Vedr.: Diode for horn, X1	PUP nr.:	25-004
	Udarbejdet af:	LPA
	Dato:	15-04-2025
	Intern <input checked="" type="checkbox"/>	Ekstern <input checked="" type="checkbox"/>

Regarding: Diode for horn, X1	PUP No.:	25-004
	Prepared by:	LPA
	Date:	15-04-2025
	Internal <input checked="" type="checkbox"/>	External <input checked="" type="checkbox"/>

Diode for horn - X1

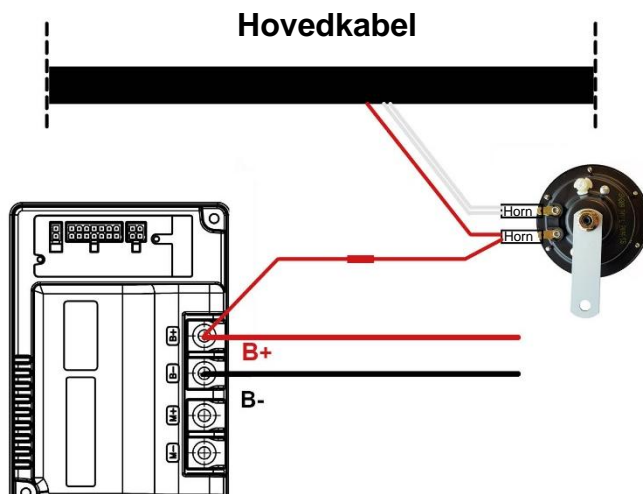
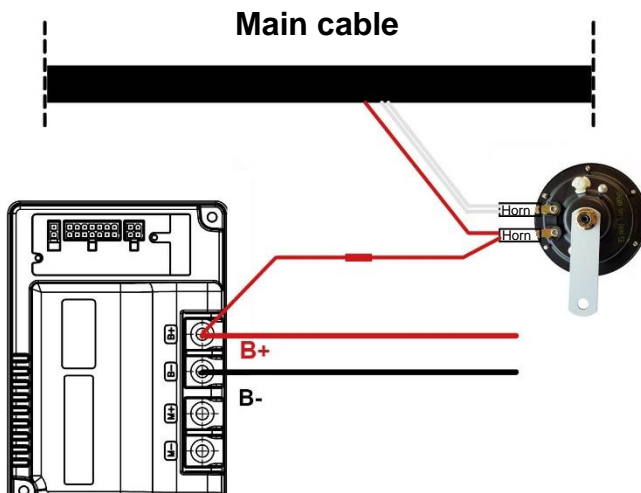
Fra Serienummer 03-52797-22-06 blev en diode monteret som vist nedenfor. Det har dog vist sig ikke at løse alle problemer.

Derfor har vi flyttet diodens placering, så den nu har forbindelse til B+

From Serial Number 03-52797-22-06 a diode was fitted as shown below. However, this has not proven to solve all problems.

Therefore, we have moved the diode's location so that it is now connected to B+

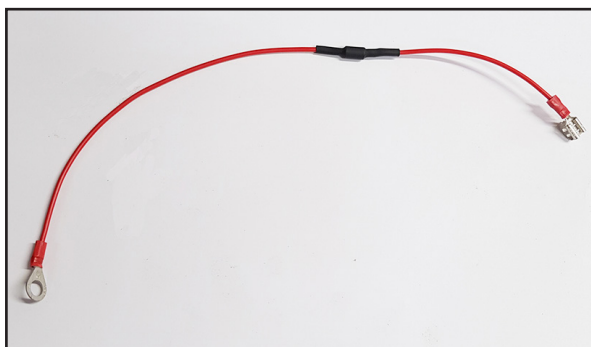
From Serial Number 03-57970-25-02 is a diode 1505-1572 Diode for horn, mounted as in the picture below.

In case the diode needs to be retrofitted, the previous diode must be removed.

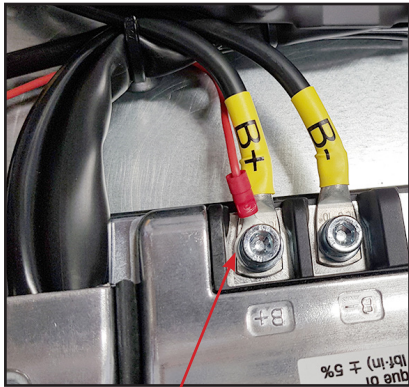
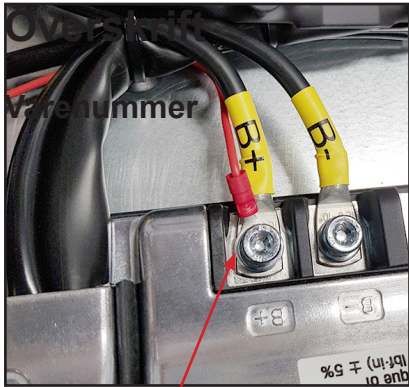
Fra Serienummer 03-52797-22-06 blev en diode monteret som vist ovenfor. Den skal afmonteres før den nuværende diode monteres.

From Serial Number 03-52797-22-06 a diode was installed as shown above. It must be removed before the current diode is installed.

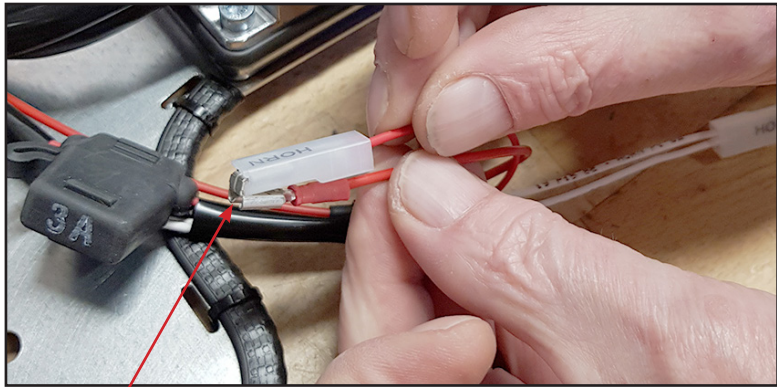
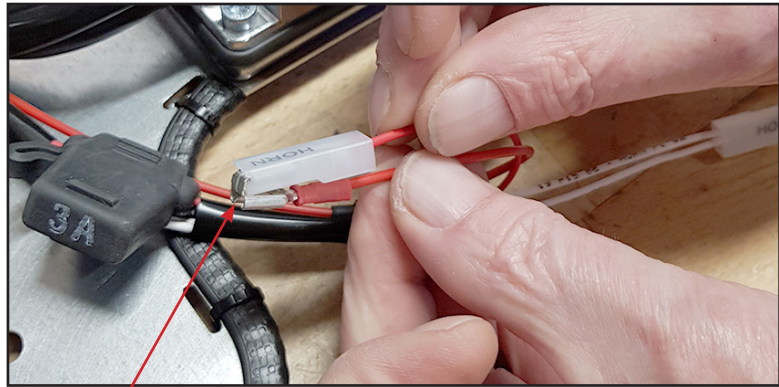
Ny diode - kabelskoen på diode-sættet monteres sammen med B+.

New diode - the cable lug on the diode set is mounted together with B+.

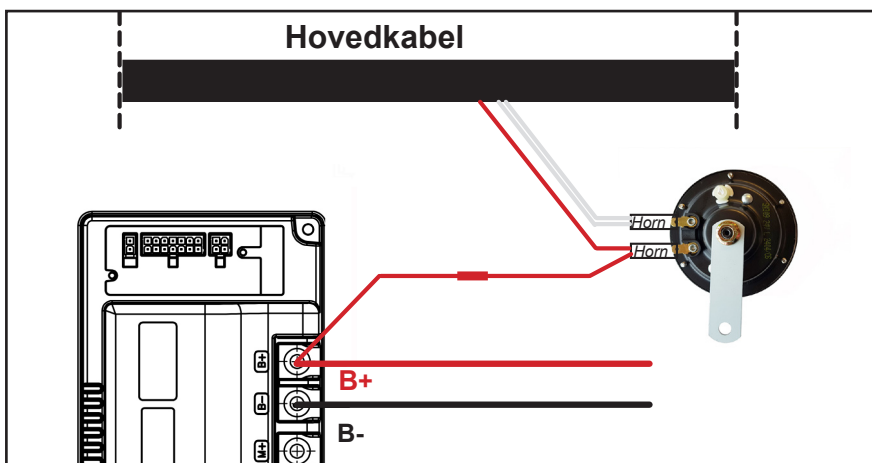
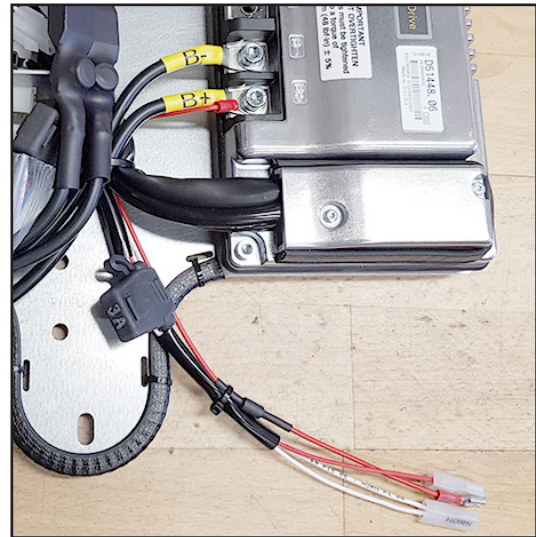
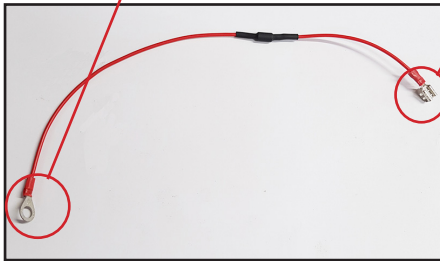
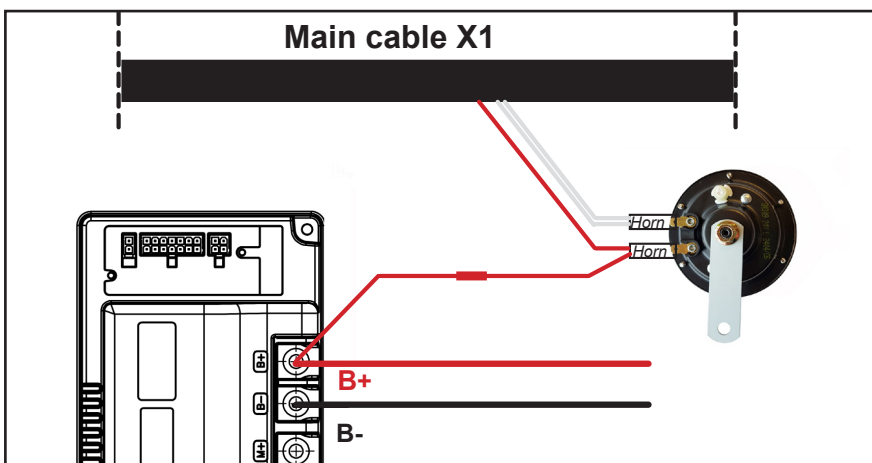
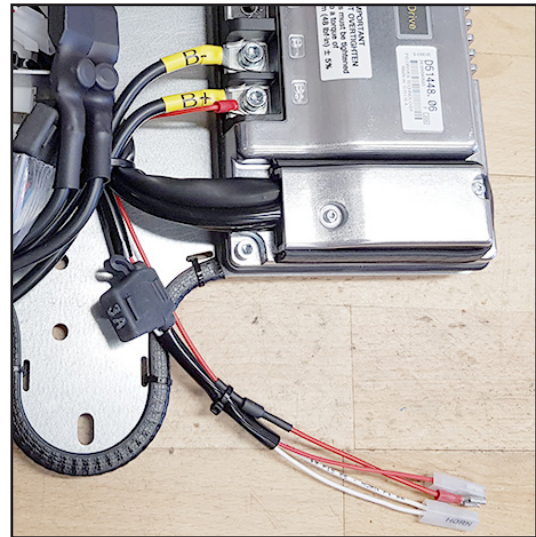
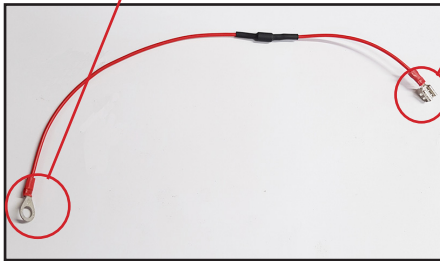
Stikket i den anden ende monteres på det røde Horn kabel. Klipses i som vist.

The connector at the other end is mounted on the red Horn cable from til Main cable. Clip in as shown.
